DUE TO LIMITED TIME, ONLY CERTAIN GUIDANCE ITEMS
FROM 11/12 EDG MEETING ARE ADDRESSED IN THIS
PACKET. FURTHER DETAIL AND ADDITIONAL INFORMATION WILL
BE PROVIDED IN PRESENTATION ON 12/16

# TABLE OF CONTENTS APPENDIX B:

(based on Design Review Board statements and categories of focus at 11/12 EDG meeting)

# **RESPONSE TO EDG 1 GUIDANCE**

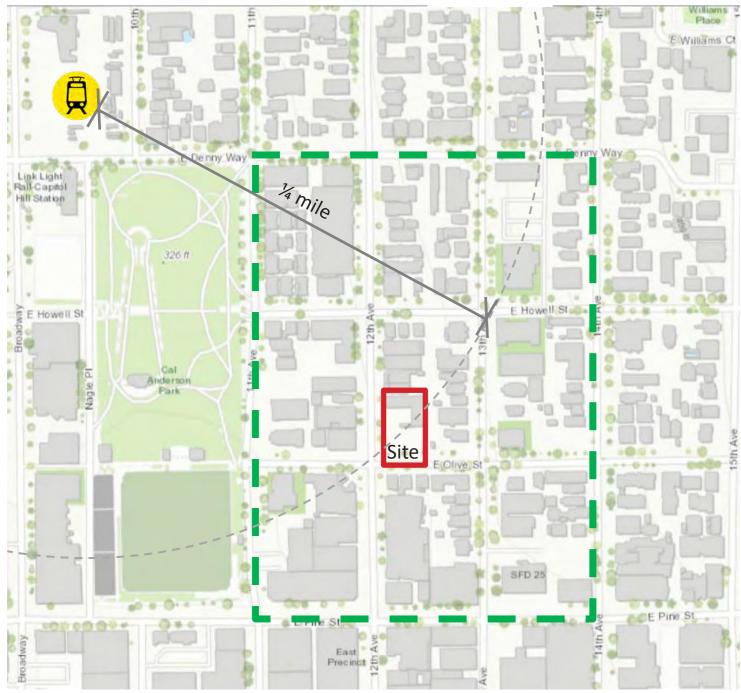
- AH-"Did not respond in terms of exploring massing alternatives to fit that rhythm of the neighborhood and transition."
  - See additional analysis of neighborhood and site confirming 40 and 60' predominant parcel but also 25-30' widths and 25-30' width buildings as well.

- LP-"Hard time connecting/understanding what moves were in relation, and those to context."
  - See diagrams showing various rhythms and scales as noted above adopted from the immediate and surrounding neighbors and applied to guide the modulation of the facades

- MA-"Fair or honest contextual examples, similar scales, similar modulation."
  - Note that tertiary (recommendation level detail) will be included in the next steps to further emphasize and tie this building to its surroundings

- AH-"More of tie(to) what (is) specific about building is Capitol Hill."
  - The building character anchors to Capitol Hill in different ways on the different schemes but the massing and secondary massing is linked as diagrammed to the fabric of the neighborhood. As seen radiating out from the new light rail station, the new zoning is changing the character of the neighborhood. This building pulls different in fluences from the area to make it contribute to this evolving fabric but also emphasize important features of Capitol Hill including:

- Unique, interesting, artistic form overall
  - Livable, shareable spaces dispersed throughout
  - Materials reflective of the neighborhood
  - Supportive environment and space for small business

- Celebrating art and sustainability

#### **OPTION C UPDATED - SUMMARY**

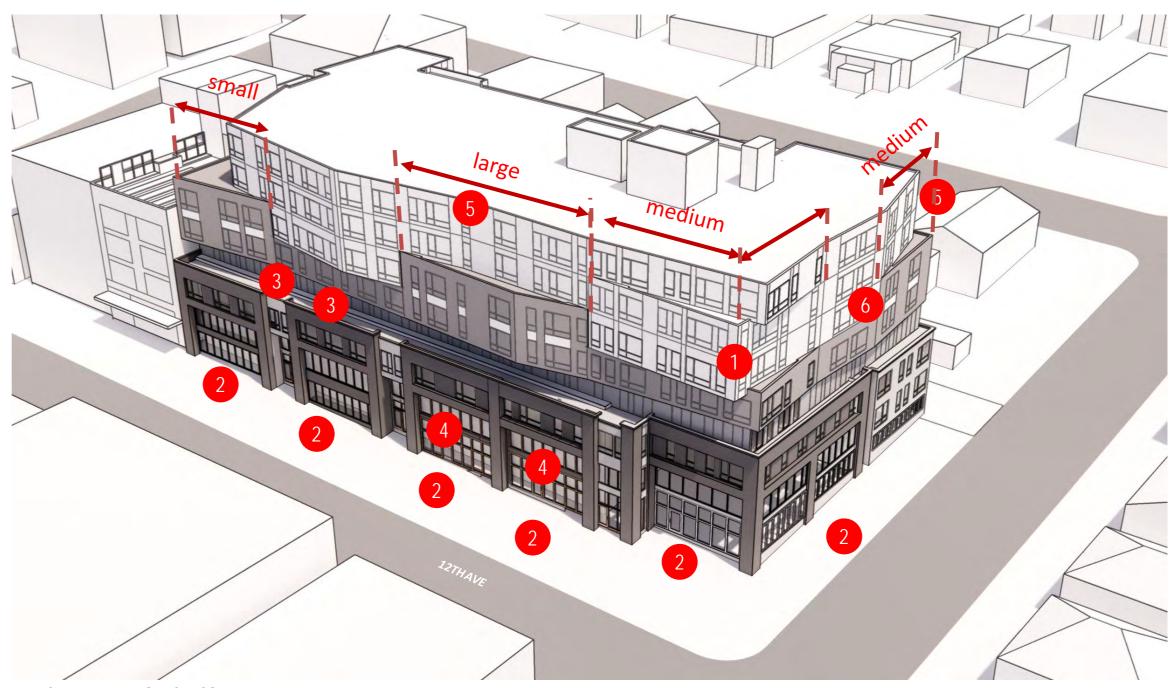
- Option C.1 has been provided with the same base as C as an option to flatten out and simplify the upper floors.
- 3 EG-"Appreciate how options C/D tried to break down the scale along 12th and alley. North and south need some consideration."

- •Unit Count = Approx. 144
- •Approx. 102,500 GSF residential
- •Approx. 4,000 GSF commercial
- •FAR = 5.86
- •75' Above Average Grade
- •Code compliant no departures
- ADJUSTED BASE:
  - ORTHOGONAL CORNER
  - NARROWED BRICK PIERS (5' down to 3.5')
  - PAREPETS & MATERIALS
  - WINDOWS TO FIT WITH COMMERCIAL
- PUSHED UPPER-LEVEL CORNER ANGLES AS
- FAR AS POSSIBLE
- SOUTH SIDE:
- ADJUSTED ANGLES AND MATERIALS TO BREAK UP FURTHER

EDG 2 VERSION (Option C ) – NOVEMBER 12, 2020

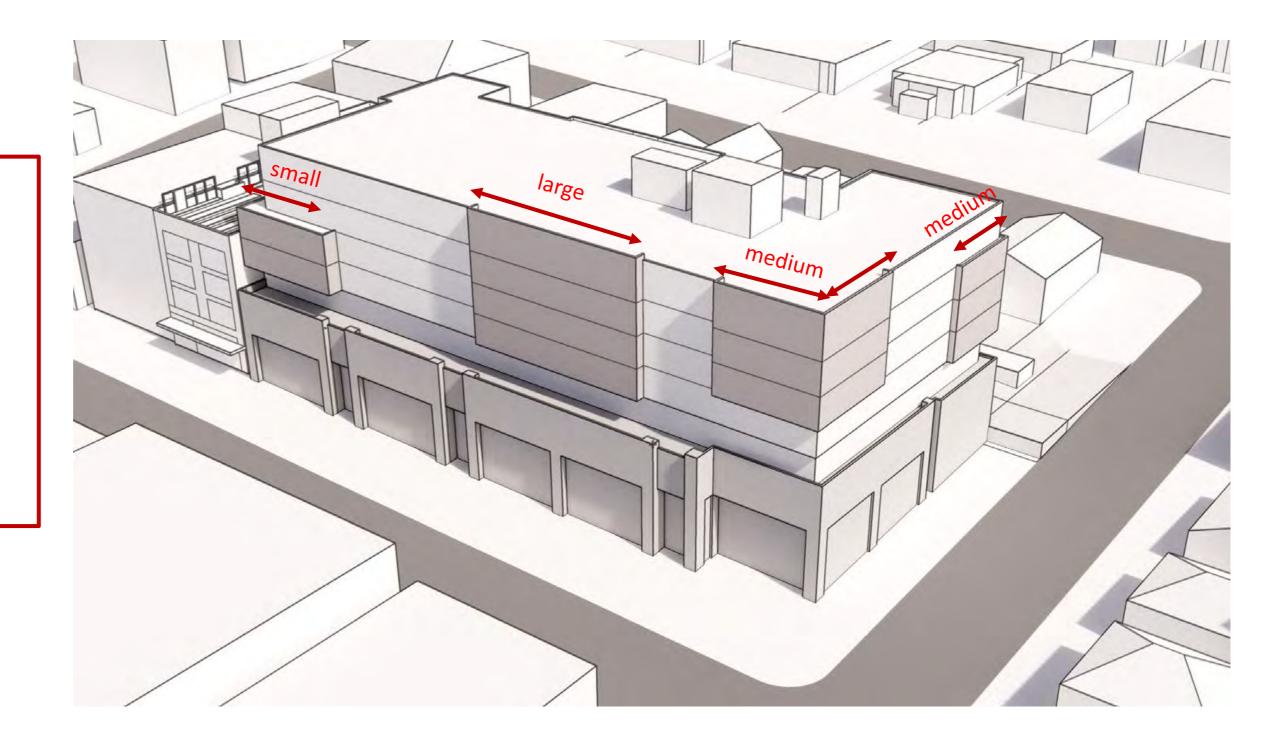
- AH-"Step down and setback from the "much lower" density to the east....there's a way to break down to feel like its not one bulky mass ."
  - Option C has been further developed with additional stepdowns and setbacks at the east facade (transition) upper-level corners.

- LP-"Option C feels a bit busy (upper levels)....North setback at upper levels successful and could be applied to the other corners, especially transitions to residential zone to east....more dramatic massing shift at SW(upper) corner."

#### • EAST SIDE:

- TOP FLOOR CORNER ANGLED SETBACKS EXTENDED ONE MORE FLOOR DOWN
- RAISED HEIGHT OF BAYS AND EXTENDED RECESSED GASKETS TO PARAPET

#### EDG 2: STREET EDGE - LOBBY AND COMMERCIAL - POTENTIAL FUTURE COMMERCIAL SPACE

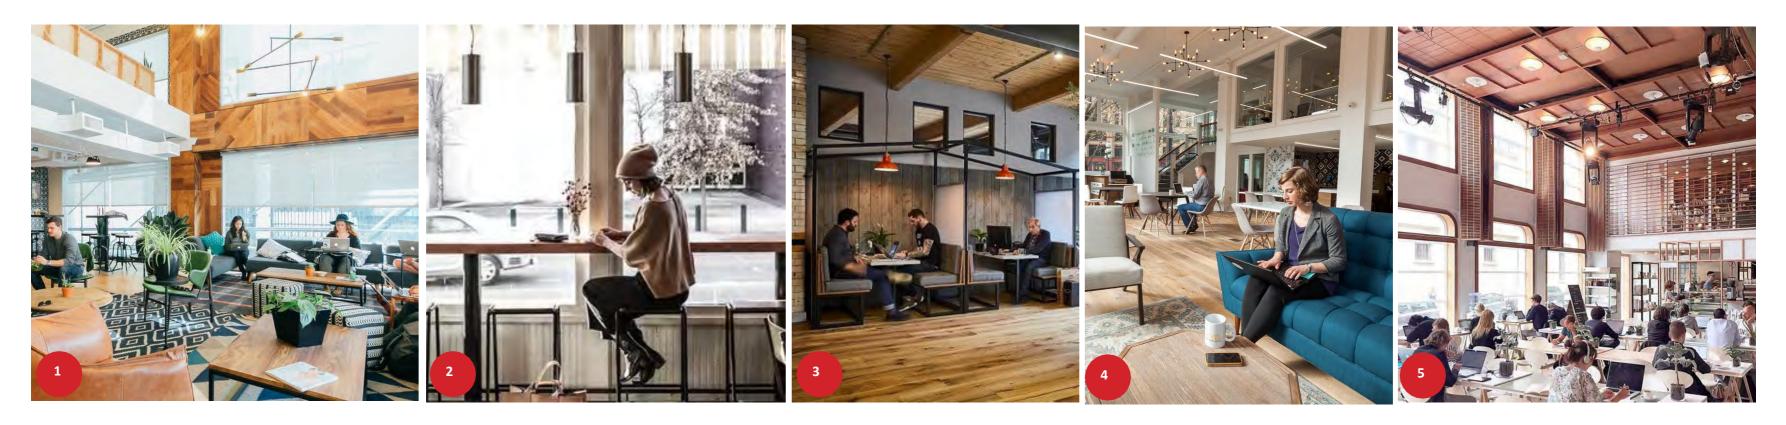
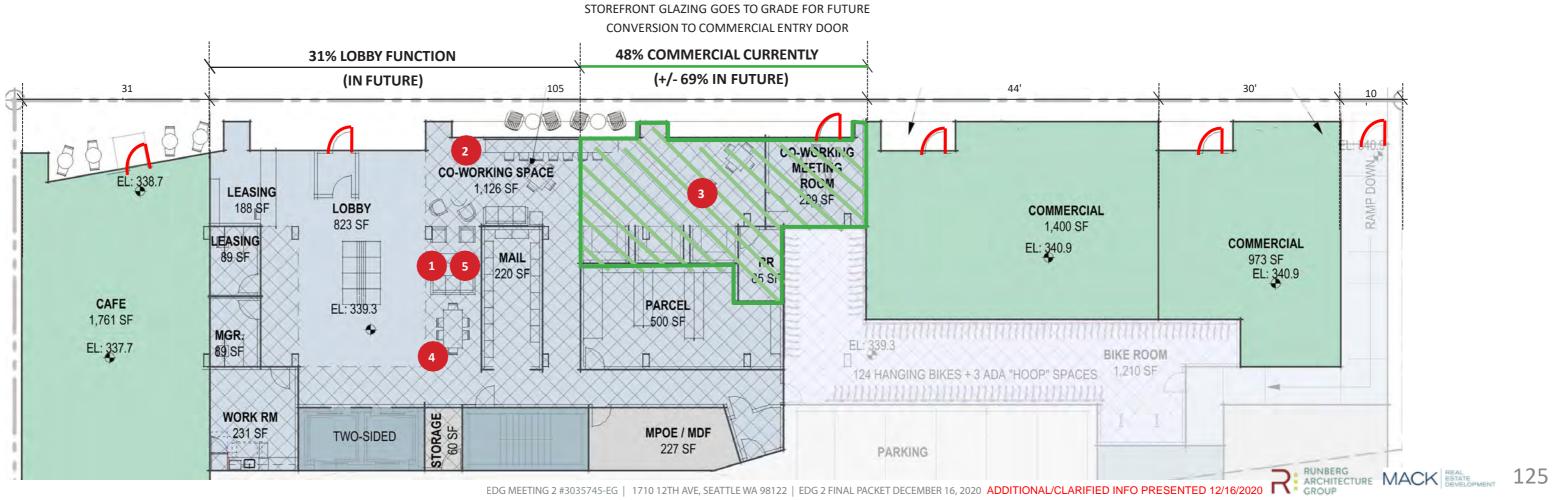
- AH-"More porosity, more outdoor seating. Appreciate height at retail spaces. Concerned about long lobby. Concerned about alley streetscape.... Blank space along 220'...we saw units opening...onto that type of space...from a safety standpoint."

- LP-"Massing help to clearly identify the residential entry ...C did a good job of breaking up the scales and massing at ground level.....develop material choices...further break down façade...consistent glazing strategy along 12th."

- MA-"Doesn't seem to be significant rhythm or repetition in those bays harkening back to the parcels/other conceptual reason....more porosity using more entrances

- EG-"Operable windows making it porous even if it is not an entrance."
  - Option C, C.1 and D:
  - Further emphasis has been provided to identify the residential entry (linked to neighborhood rhythms, heights and widths.

- Additional Porosity is being studied
- 6 AT-"Study angle at corner, divergent from rest of base orthogonal logic."
  - Corner at cafe has been adjusted be orthogonal giving more outdoor seating space and supporting the dichotomy/contrast of the podium form vs the upper form

- Parapet heights further emphasize these moves.
  - Materials are being developed to also break up massing.
  - Opportunities for art are being identified and reserved

- Glazing is being adjusted to blend living space with commercial space resulting in playful, but consistent facade design.
  - Piers/Pilasters and the amount of dark brick has been reduced to closer match widths of historic/local buildings.

Portion of co-working lobby prepped for future conversion to commercial

Co-working bar space with operable windows

Lobby entry double height similar to adjacent commercial spaces

12TH AVENUE

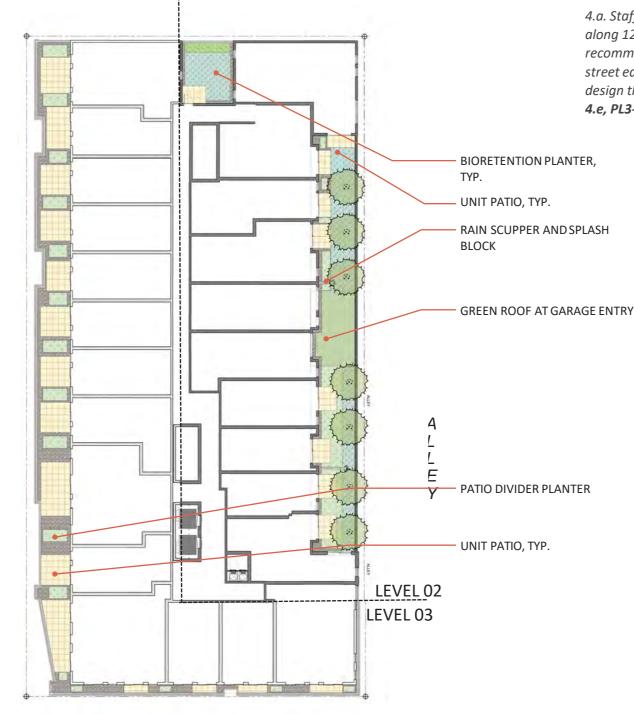
4.a. Staff supports the programming of active commercial uses along 12th Ave. In agreement with public comment, Staff recommends further development of a porous and engaging street edge with pedestrian amenities, landscaping, and a design that responds to the commercial context nearby. (CS1-4.e, PL3-B, PL3-C)

All at grade facade will feel commercial in nature. There are no residential units at grade.

Outdoor spill-out space is included and blends with the lobby outdoor seating area and landscaping.

Street trees will be increased. Only one of the (6) existing street trees is healthy and will be retained. All others will be replaced with (9) additional new large caliper trees with lush planting. The building is set back from street property line to allow space for trees and generous sidewalk space.

### Opt. C at 11/12 EDG 2

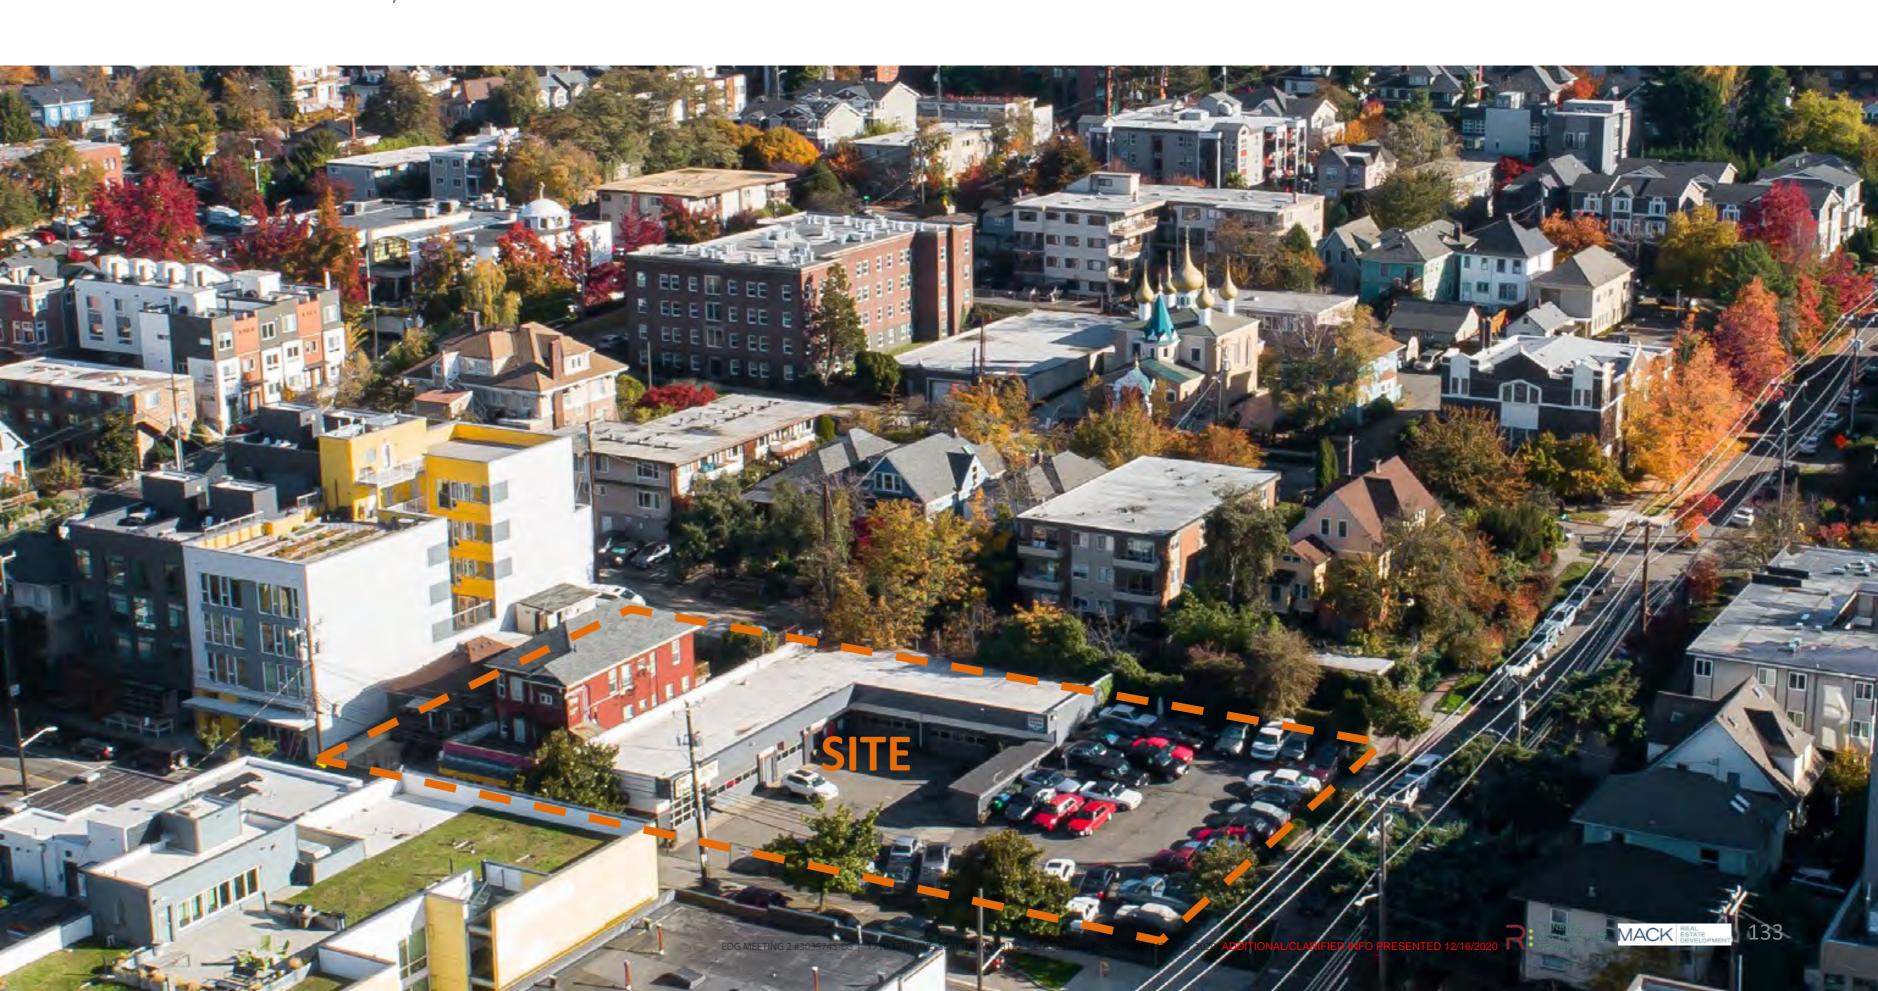
- 3 Alley-"Concerned with height and length of solid wall... Provide those pedestrian view from the alley."
- Alley-"Get some more regular eyes and transparency on the alley...choice of the applicant to actually stage dumpsters in alley and to the extent that there could be some nooks or niches."

- -Elevation of EDG 2 (11/12 meeting) is provided showing that podium wall is lower than may have been perceived. Varies from +/- 1' below unit floor at north end to 10' high near south end of courtyard with glass rail and planting above.

- -Alley has two garage doors, some air circulation screens, and windows at north and south ends with at least three units with eyes directly onto the alley.

- -Some pedestrian views in the alley have been provided. these will be developed for the 12/16 meeting.
  - trash pick up is being dictated by SPU and not allowing internal storage of dumpsters. Alcoves were also explored but would not fit with internal circulation or the grades of the alley.

- We will develop circulation diagrams for the 12/16 meeting.

#### POTENTIAL MATERIAL CONTEXT

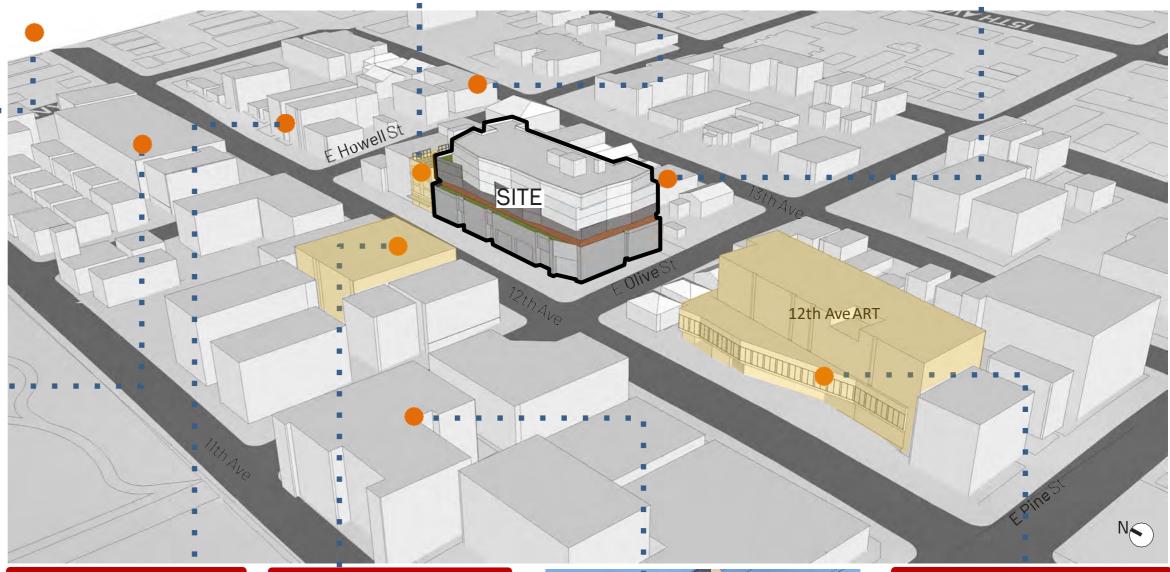
- AH-"The extensive use of Hardie panels and the, the size of the windows on 12th avenue is not up to the standard of recent projects approved by the board."

- MA-"If cementitious panel is used, it would certainly not be in the quantity that is shown right now..."
- LP-"Materials...on that base...to really help to breakdown the scale...looking at some variations there(in the colors/tones)...that incorporating art at...street edge."

- 4 AT-"Tall ceiling heights in the retail space...the part where...I would feel this is not very appropriate to 12th ave. in that there's not much to bring the scale down to... more of a human height..along the side...."

- Hardie is used extensively in the neighborhood
  - We have had success (award winning projects) using Hardie and detailing it correctly.
  - Widows are at the maximum allowed by energy code.

- As noted / shown in section III (at grade detailing), we are incorporating various materials and colors breaking down 12th Ave and E. Olive St. podium

- Additionally, materials, minor modulation in storefronts and bays, canopies / signage yet to be designed will break the street facade down to pedestrian scale as indicated in some of our other successful projects.
